## Flexible Resource Adequacy Capacity Must Offer Obligation Phase 2 Straw Proposal

Submitted by	Company	Date Submitted
Nuo Tang <a href="mailto:ntang@semprautilities.com">ntang@semprautilities.com</a>	San Diego Gas & Electric	January 8, 2016

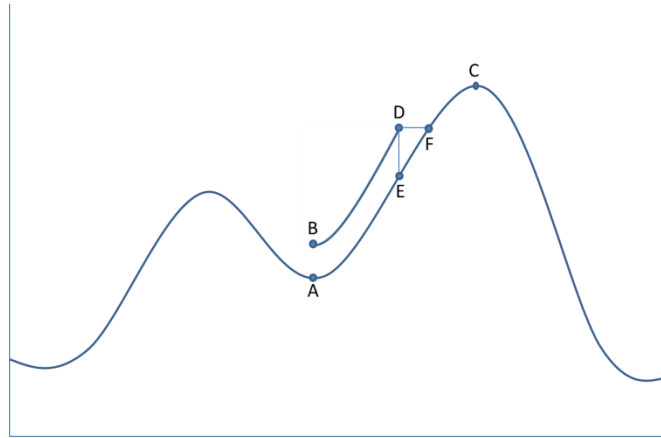
SDG&E agrees with ISO's graph that once the charging portion stops, the net load curve shifts back to the original net load curve. However, SDG&E is uncertain if the 3 hour ramp from points A to C is the same as (C-B) plus (B-A). Using a slightly modified version of ISO's Figure 4 below, SDG&E questions whether the ramp is (D-B) plus (C-E) plus (D-E)? Or is it (C-B) plus (F-E)? ISO suggests that because the charging stops, the ramp must recover the charging segment with an instantaneous ramp. If this is the case, then the ramp would actually be greater than the original ramp by the difference of the charging amount. SDG&E recommends more discussion on this topic.
